UNITED STATES PATENT AND TRADEMARK OFFICE

APPLICATION NO.	FILING DATE	FIRST NAMED INVENTOR	ATTORNEY DOCKET NO.	CONFIRMATION NO.
09/851,576	05/10/2001	Yao-Ching Su	ADTP0033USA	3197

Office Action Summary

DETAILED ACTION

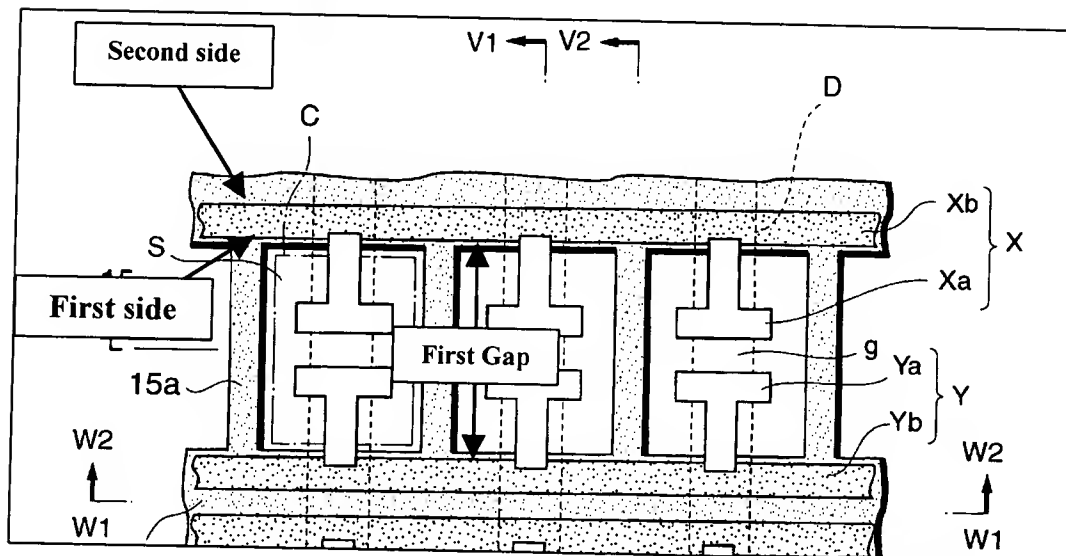
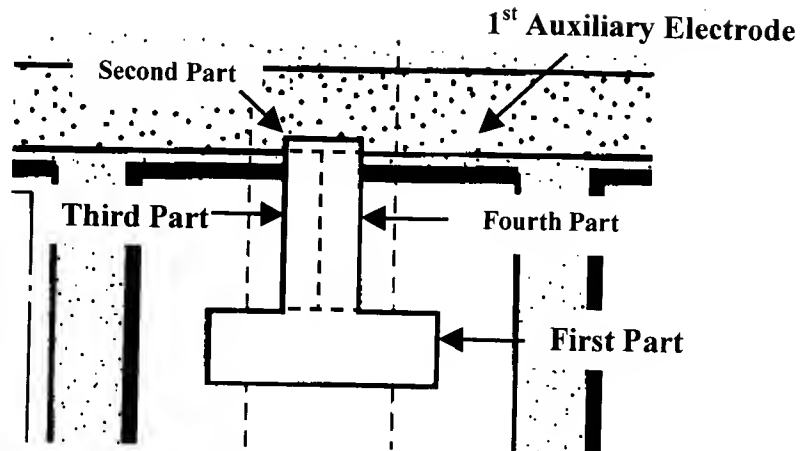
In regard to claim 1, Koshio teaches in figures 1 and 2, an electrode structure of a plasma display panel with a first sustaining electrode (Xb) and a second sustaining electrode (Yb) set on the surface of the front substrate (10), and a first gap (shown below) existing between the first and second sustaining electrodes, the first sustaining electrode having a first side (shown below) approaching to the second sustaining electrode and a second side (shown below) far from the second sustaining electrode; and a first auxiliary electrode (Xa) electrically connected to the first sustaining electrode, the first auxiliary electrode comprising a first part (shown below) and a second part (shown below), the first part formed in the first gap (shown below) and the second part located above the first sustaining electrode; wherein a second gap (g) exists between the first part of the first auxiliary electrode and the second sustaining electrode, and the width of the second gap is smaller than the width of the first gap.

Koshio further teaches in figure 1 that the first auxiliary electrode further comprises a third part (shown above) approaching to the second side of the first sustaining electrode.

In regards to claim 9, Koshio teaches in figures 1 and 2, an electrode structure of a plasma display panel with a first sustaining electrode (Xb) and a second sustaining electrode (Yb) formed on the front substrate (10), and a first gap (shown above) existing between the first and second sustaining electrodes; and a first auxiliary electrode (Xa) formed on the surface of the substrate in the first gap; wherein a second gap (g) exists between the first auxiliary electrode and the second sustaining electrode.
